Nessfield Accessibility Action Plan

4.1 Action Table				
COSTS – N = NONE M= MINIMAL OG = ONGOING MAINTENANCE ST = STRUCTURAL CHANGE EX = MAJOR STRUCTUARL CHANGE				
Item Ref.	Details/Issue	Recommendation	Est Cost	Action Taken
PRIORITY A

6.5

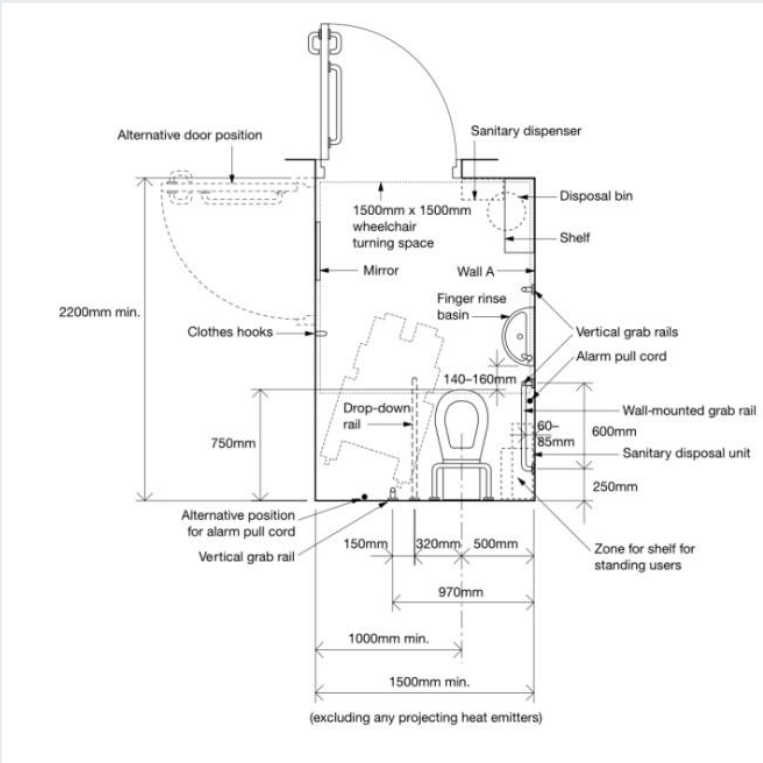
There is no induction loop provided to the reception desk to accommodate hearing aid users who struggle when there is background noise.

Install an induction loop to the reception desk. Install signage indicating the availability of the facility and ensure that staff members are aware of how to use the system. ADM vol-2 requires that any reception point is provided with a hearing enhancement system, e.g. an induction loop and the presence of an induction loop or infrared hearing enhancement system is indicated by the standard symbol:

2.5

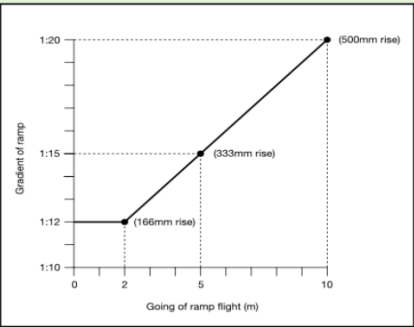
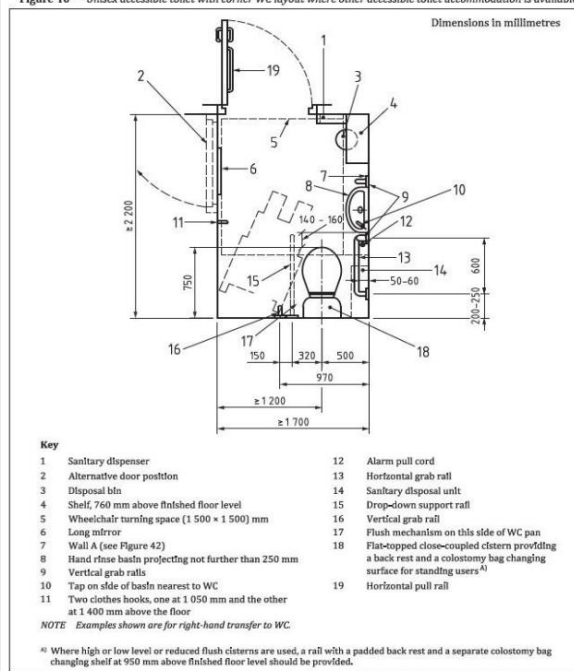
Intercom located high at 1350mm from ground level and difficult to access from within car due to location.

There is a gate which needs to be opened and opens towards you as you approach it. It is heavy and does not have a pedestrian side gate.

There is a kerb as you approach but a dropped kerb to the crossing point to the left.

It would be recommended to have a marked route from the accessible bays to the main entrance.

Provide an accessible parking space in an area which provides level access to the accessible/ main entrance or provide a suitable access route from the current location - refer to 2.4. BS8300 recommends that designated accessible parking spaces in uncovered parking areas should be located on firm and level ground, as close as is feasible to the accessible entrance to the building.

The route should either be level along its length or should be gently sloping or incorporate a ramp or ramps, with the lowest practicable gradient within the range 1:20 to 1:12 and the maximum corresponding length between landings. Refer to BS8300 for further details.

Any side-hung gate on an accessible route should be capable of opening in both directions and of being opened easily with either hand, and should be self-closing. Fencing and guardrails should contrast visually with the background against which they will be seen, under a variety of lighting conditions.

ADM vol-2 requires that controls or switches requiring precise hand movements are located between 750-1200mm above the floor. BS8300

13.3

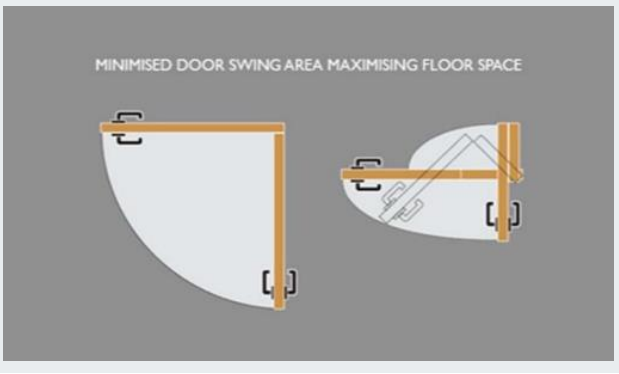
The Accessible WC with shower and hoist in room 39 has an inward opening door. It is used as first aid room. Kept locked - key locker, located high.

BS8300 recommends outward opening doors in regard to sanitary accommodation. However, the use of reduced-swing door sets, which have a sliding/folding action, reduces the door swing into the room and corridor and supports manoeuvring in and out of toilets and bathrooms.

Any door to sanitary accommodation, whether opening inwards or outwards, should be capable of being opened in an emergency if a person inside has fallen against it and is unable to move. The use of pivot hinges, in conjunction with an emergency release door stop and bathroom lock openable from the outside, can provide this facility.

If required, would be recommend to consider the option of the use of a Pivette door such as seen here:

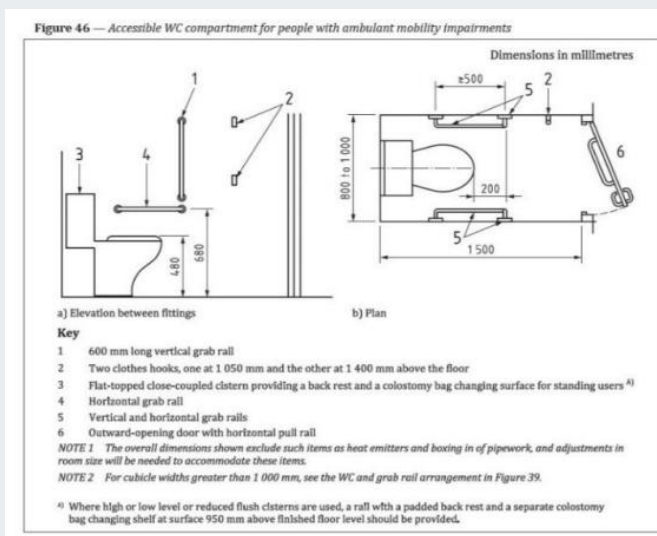
6.4	<p>The reception does not have colour contrast provided to the front to aid people with impaired vision.</p>	<p>It is recommended that a section of the flooring 1500x1500 in front of the reception desk be replaced with an alternative that is suitably colour contrasted. This will aid people with impaired vision when attempting to locate the reception desk.</p>	M

12.8

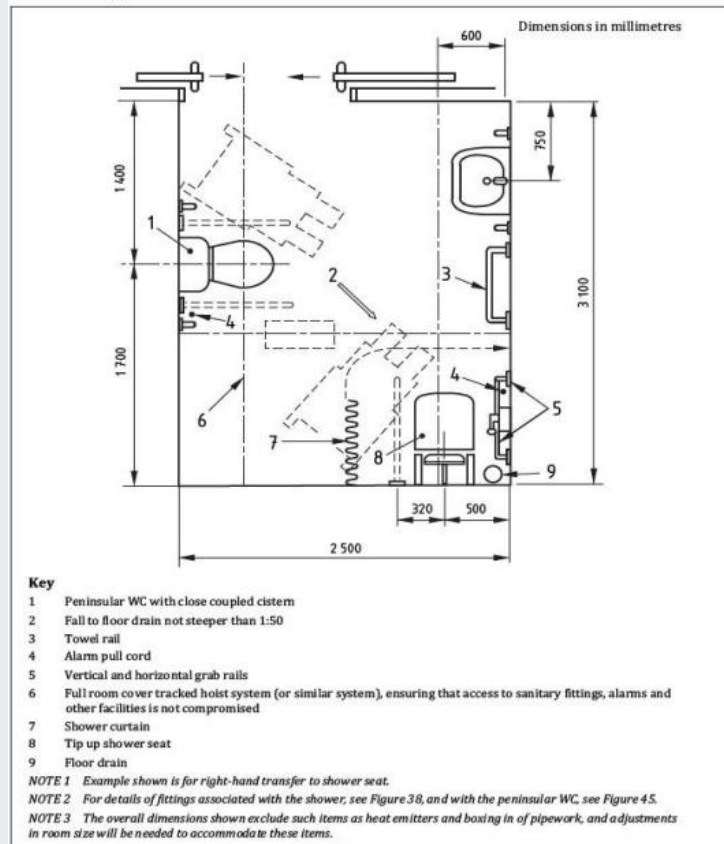
An accessible shower is provided if this is not in regular use. This does not have grab rails but a seat is provided.

A hoist is provided but this is now obstructed by the frame for the shower door and curtains.

As the hoist cannot be used currently, and modifications to the shower will be needed to allow this to be used, consideration should be given to refurbishing the room to provide an accessible shower room with a fully accessible WC (as recommended in 13.1) along with a suitable hoist and changing mat for assisted changing and a level access shower such as recommended in BS8300 and shown below (refer to BS8300 for other layout options):
